Access Compliance Report

Public Rights-of-Way

Intersection ID: 44932	Main Street: NATHAN_DR	Cross Street: BRUMIT_LN	Location: NW
ADA ID: FF3E05CCA234	Ramp Type: PerpDiag	Initial Pass/Fail: Fail	Overall Compliance: No
		Severity Score: 10

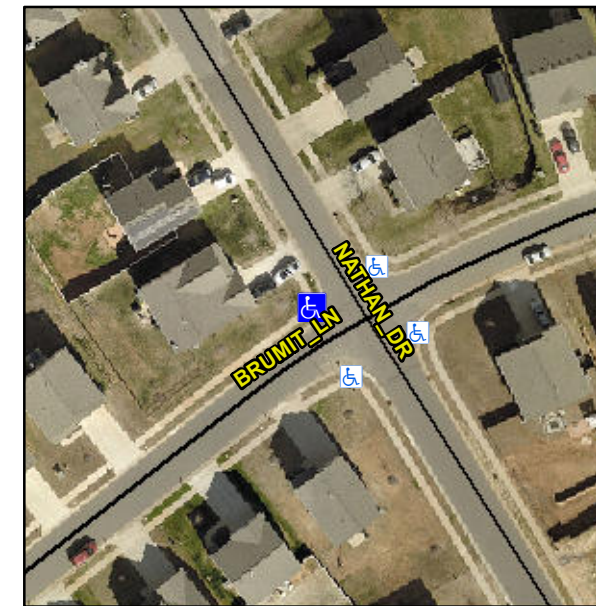
Not Found, R304.5.1, R304.5.3

Compliance	Description	Data	Compliance	Description	Data
N/A	Ramp Length (in)	47.5	Yes	Ramp Slope (%)	7.5
No	Ramp Width (in)	47.0	No	Ramp XSlope (%)	2.4
N/A	Flare Type LT	N/A	N/A	Flare Type RT	N/A
N/A	Flare Slope LT (%)	N/A	N/A	Flare Slope RT (%)	N/A
N/A	Flare Traversable LT?	N/A	N/A	Flare Traversable RT?	N/A
N/A	Landing Length (in)	N/A	N/A	DWS Provided?	N/A
N/A	Landing Width (in)	N/A	N/A	DWS Contrast?	N/A
N/A	Landing Slope (%)	N/A	N/A	DWS Length (in)	N/A
N/A	Landing X Slope (%)	N/A	N/A	DWS Full Width?	N/A
N/A	Landing Curb? (Y/N)	N/A	N/A	DWS Offset (in)	N/A
N/A	Shared Landing?	N/A			
N/A	Gutter Ponding?	N/A	N/A	Gutter Slope (%)	N/A
N/A	Gutter Lip Ht (in)	N/A	N/A	Gutter X Slope (%)	N/A
N/A	Painted X Walk1?	No	N/A	Painted X Walk2?	No
	X Walk 1 Direction	To SE		X Walk 2 Direction	To NE
N/A	X Walk 1 Width (in)	N/A	N/A	X Walk 2 Width (in)	N/A
	X Walk 1 Slope (%)	2.5		X Walk 2 Slope (%)	4.0
	X Walk 1 X Slope (%)	0.6		X Walk 2 X Slope (%)	5.2

Remove & Replace Curb Ramp With Two New Directional Ramps or Equivalent.
